**Section 11**  
**'AN' AND ARMY EQUIPMENT**

**COMMUNICATION EQUIPMENT MAINTENANCE BULLETIN**

## SECTION II. 'AN' AND ARMY EQUIPMENT

FIGURE 1.—Rack mounting for AM-215/U and AM-215A/U amplifiers. For text see Page AM-215/U : 1. ←

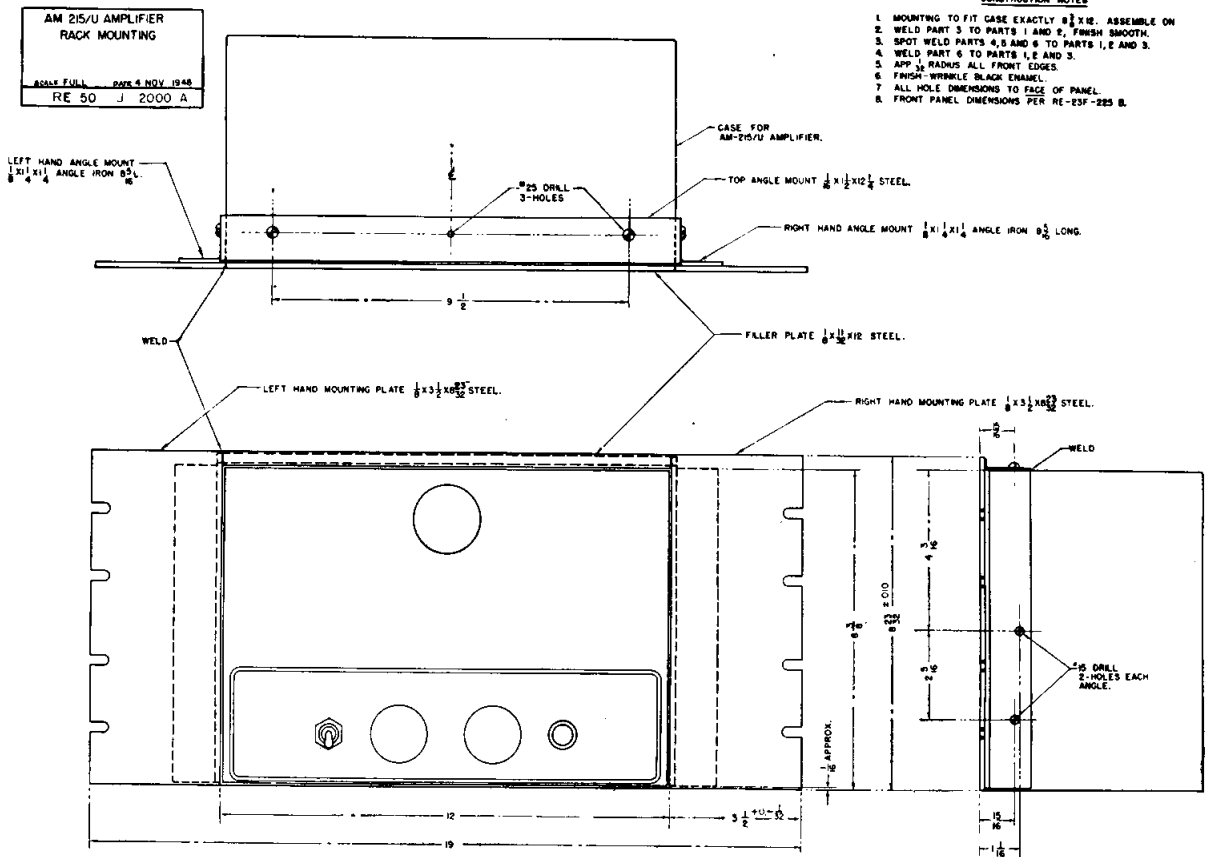
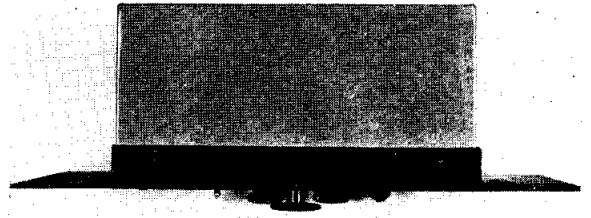
The Long Beach Naval Shipyard has designed a rack mounting for the Type AM-215/U Audio-Frequency Amplifier. Figure 1 illustrates the AM-215/U amplifier in the rack mounting. Construction data and fabrication information are also included in figure 1 for use by all Naval shore establishments.

This type of mounting with slight modification can also be used for the AM-215A/U amplifier. The front panel of the AM-215A/U amplifier will have to extend about  $\frac{3}{4}$  inch in front of the mounting rack to allow the front panel to be lowered and the hinge pin to be removed. For illustrations and diagrams see figure 1 on page AM-215/U: 3. 1/1/49.

FIGURE 1.—New crystal clamp for model AN/APN-9.

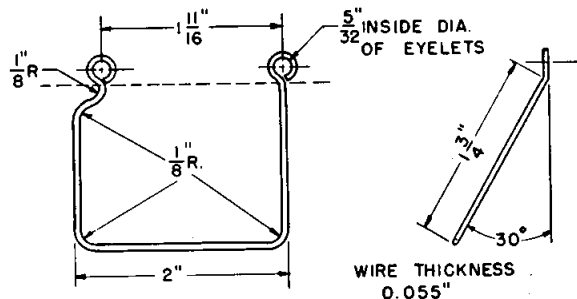
*Procedure.*—Fabricate a reinforcing spring as shown in Figure 1. Fasten the spring under the two screws holding the crystal socket supporting bracket and hook it back of the present crystal holder spring to give added stiffness.

*General.*—Shock and vibration tests at NRL indicate that difficulty may be experienced from the crystal holder coming out of the socket. This change provides added stiffness to the crystal holder spring. Figure 1 shows

FIGURE 2.—Revised arrangement.

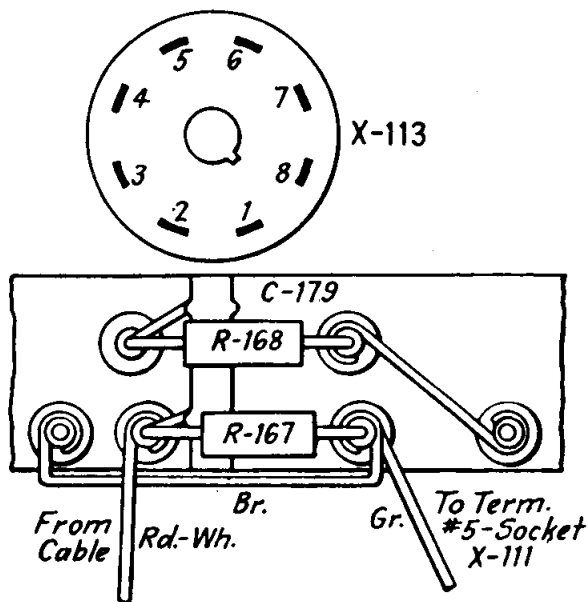
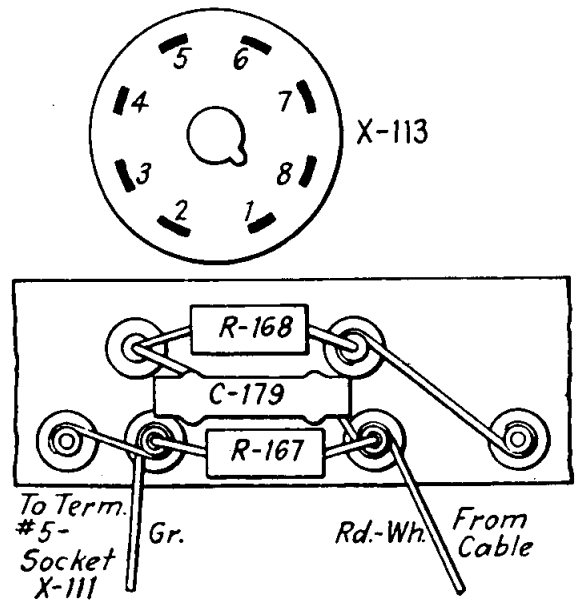
Electrical test on a quantity of these capacitors taken from the production line at Western Electric has shown that they are not adequate for this circuit application. In addition, the capacitor is mounted in the set as shown in figure

Perhaps a warning to service men that C-179

1 and may possibly have become misplaced to such an extent that the end nearest to tube socket X-113 was actually in contact with the terminals projecting from the socket. In this case the bakelite insulation on the condenser would soon wear through and result in a contact between the grounded end of C-179 and socket terminal No. 2 (heater terminal 18 volts) or No.

Future equipments commencing with Western Electric serial No. 5700 and Westinghouse serial No. 11663 will be modified to avoid trouble due to misplacement of this capacitor by rearranging the terminal board on which it is mounted, as shown by figure 2, and by substituting a 200-mmfd. 500-volt capacitor.

should have at least  $\frac{1}{8}$ " clearance from the terminal of socket X-113 is all that is warranted although the change is one that could be readily made at any repair shop. This change will also, be shown on the wiring diagram, figure 43, of the maintenance handbook when it is reissued.

FIGURE 1.—Protection for resistor mounting strip in AN/ARC-1 equipments.

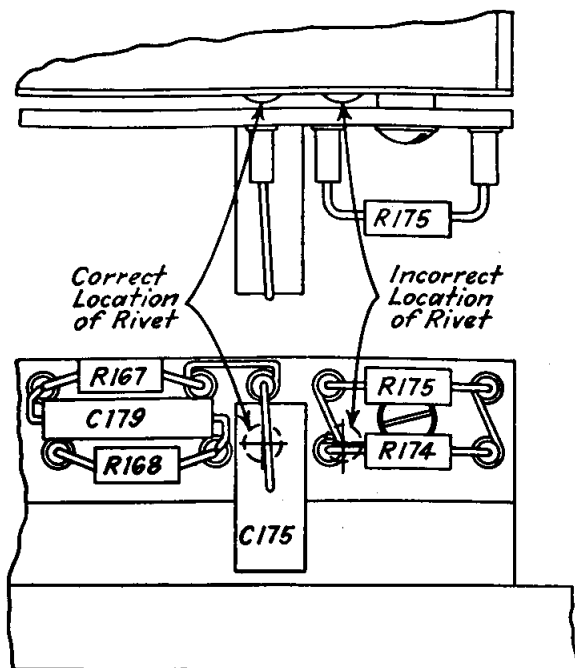
There have been sets shipped to the field, serial numbers unknown, in which the rivets affixing an insulating separator to the chassis are located so as to come dangerously close to live terminals on the resistor strip feeding the modulator audio amplifier tubes V110, V111, V112 and V113. (See Figure 1.) This condi-

tion is present in occasional sets up to current production but will not be found in sets beyond Western Electric 28000 or Westinghouse 7850. To eliminate difficulties which might arise from this source, part BA-40,789 consisting of a  $\frac{1}{32}$  inch thick phenol fiber insulator strip with properly located holes will be furnished to all service activities for general distribution. This strip should be inserted between the existing riveted-on insulator and the resistor strip which is done by removing the three screws mounting the resistor strip, slipping the new

insulator under the resistor strip until the edges conform, and restoring the three screws. Many sets are already provided with this insulator or a spacing washer and will not require any change. Examine sets not equipped with the extra insulator or spacing washer and if a rivet appears in the incorrect location as shown in Figure 1, it is an indication that an insulator strip should be inserted to avoid contact. In the correct location, no modification is necessary.

FIGURE 1.—Schematic diagram of noise limiter.

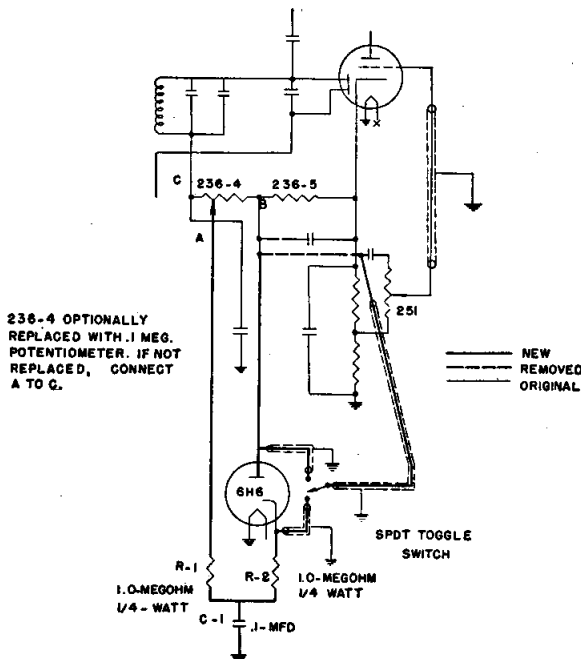
Referring to the schematic diagram shown in Figure 1, operation is as follows: Rectified signal current flows through resistors 236-4 and 236-5 causing a voltage drop in the proportion to the incoming signal amplitude. The potential across 236-5 is the audio signal voltage delivered to the grid of the 6SQ7 through the limiter tube 6H6. The potential across 236-4 operates the limiter tube. Both of these voltages can vary with instantaneous changes in signal amplitude such as occurs with noise or modulation, but the cathode of the 6H6 is not allowed to follow instantaneous voltage variations across 236-4 due to the filtering action of R-1 and C-1.

Addition of this device to the receiver does not effect the i-f alignment provided the i-f circuit wiring is not tampered with. All parts except the 6H6, switch, R-1, R-2 and C-1 are in the original circuit.

FIGURE 1.—Modification to allow remote control operation.

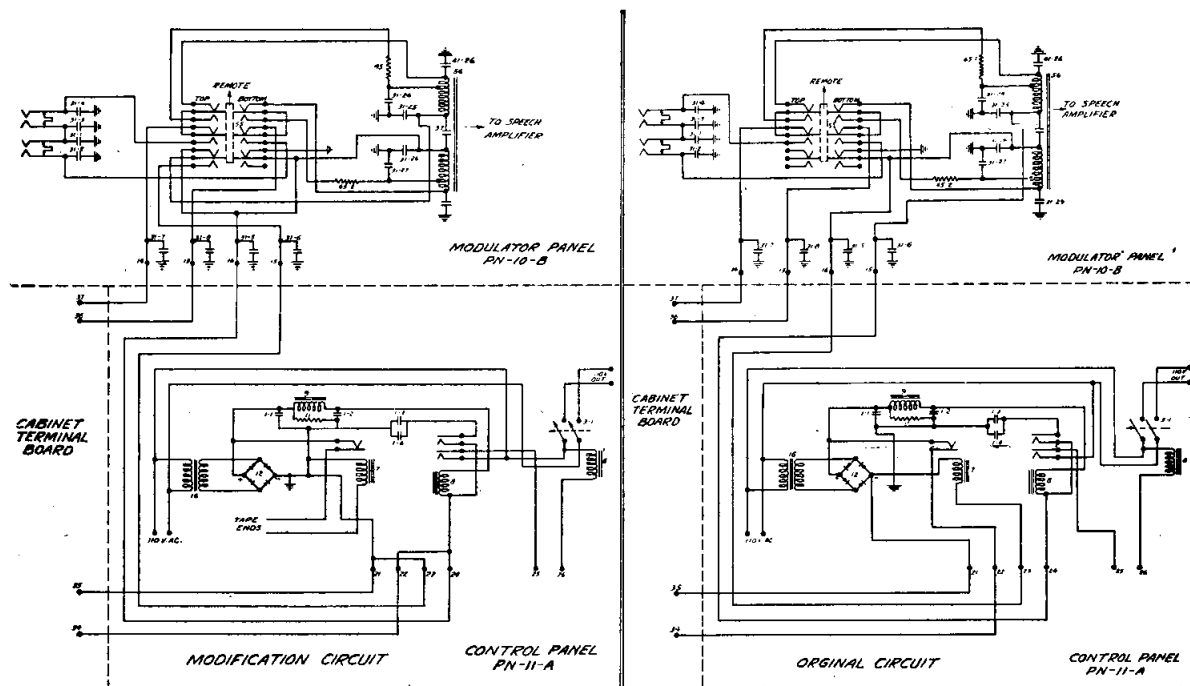
In order to provide remote control operation of the BC-640-A VHF transmitters now being installed at various Naval air activities, the following notes from a letter received by the Bureau from the Radio Material Officer, Navy Yard, Washington, are given (see Figure 1):

(2) On the original circuit on both REMOTE and LOCAL positions of switch 55 on PN-10-B, the plate control relay was in series with the mike, push-to-talk switch and the primary of transformer 34. Therefore for the modification, when switch 55 was placed in the LOCAL position, the same conditions as to keying were required; namely, the transmitter would key when the local mike was out of jack 40 or would key when the push-to-talk switch was pressed on a mike plugged into jack 40.

(4) The d-c keying voltage from rectifier 12 was used in both REMOTE and LOCAL conditions. For the modification all the blank blades on switch 55 were wired in so that plate control relay 8 was switched to the local push-to-talk circuit on the local mike when 55 was in the LOCAL position, and to terminals 34 and 35 on REMOTE position. By short-circuiting terminals 34 and 35, plate control relay 8 is energized.

FIGURE 1.—Modification to permit independent operation of the receivers of radio sets SCR-508, -608, and -808.

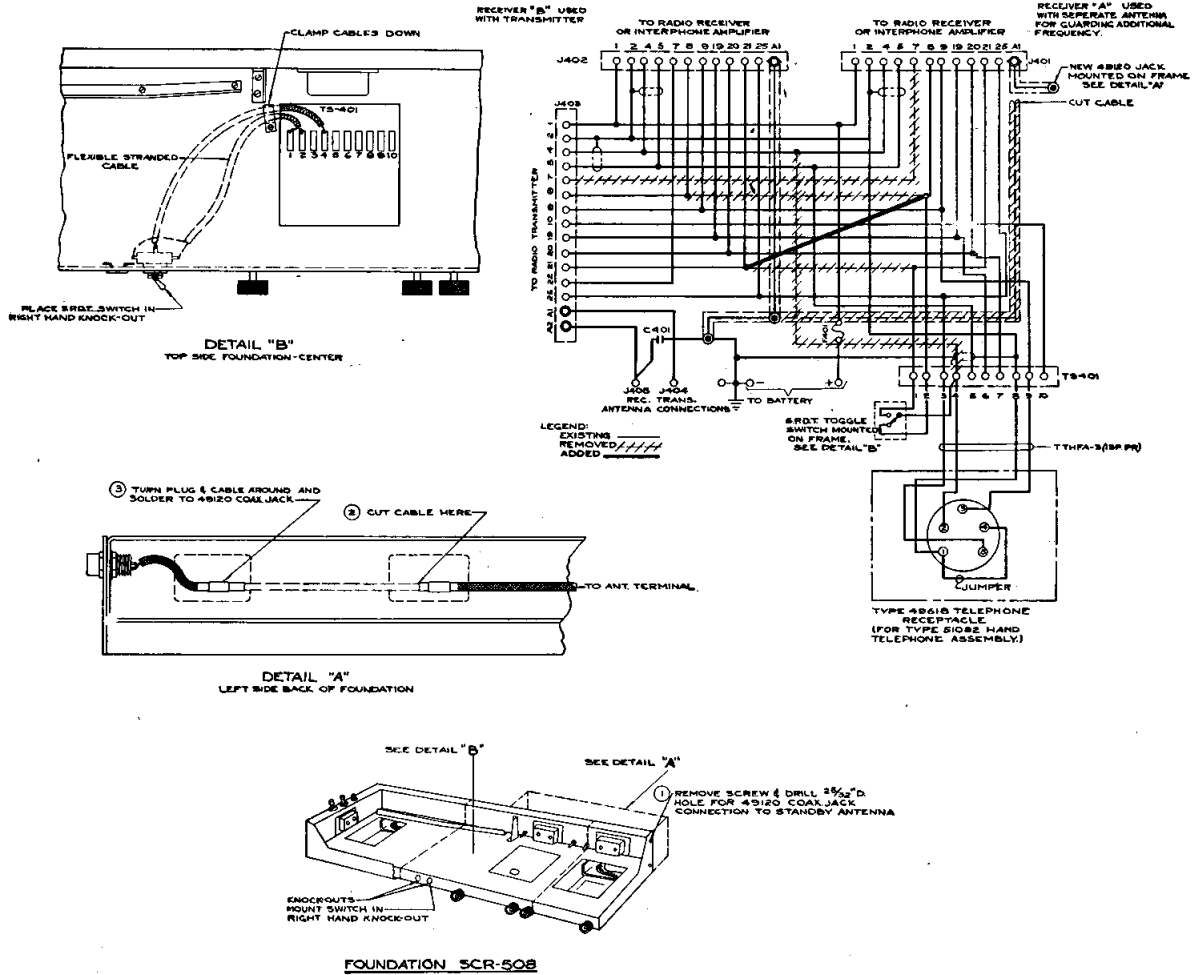
This modification, Figure 1, allows one receiver to operate on the transmitter frequency and the other receiver to operate as a standby receiver. Two antennas, therefore, are needed. The standby receiver, with its own antenna, must necessarily be set on frequencies different from those used by the transmitter and will guard one of these additional frequencies. The operating receiver is disabled and the antenna is automatically transferred to the transmitter when the latter is keyed. The standby receiver is not disabled. The single-pole double-throw toggle switch permits the transfer of the audio from either operating or standby receiver to the various remote stations.

The accompanying circuit diagram shows the changes required. The Bureau desires that these modifications be made in equipments installed in new construction vessels by the cognizant Radio Material Officer either prior to the delivery of the vessel or during the outfitting period. Ships having qualified technicians are authorized to make similar modifications on equipments already installed in vessels of the amphibious force.

- (1) Remove lead (white with red-brown tracer) between receiver A connection receptacle J-401, pin 7 and transmitter connection J-403, pin 7.
- (2) Remove lead (white with red-green tracer) between J-403, pin 21 and J-401, pin 21. Retain lead (white with red-green tracer) between J-401, pin 21 and mounting plate terminal strip TS-401 terminal 1.
- (3) Clip lead (white with brown tracer) between receiver B connection receptacle J-402, pin 8 and terminal strip TS-401, terminal 2. Splice this lead to the lead remaining on J-402,
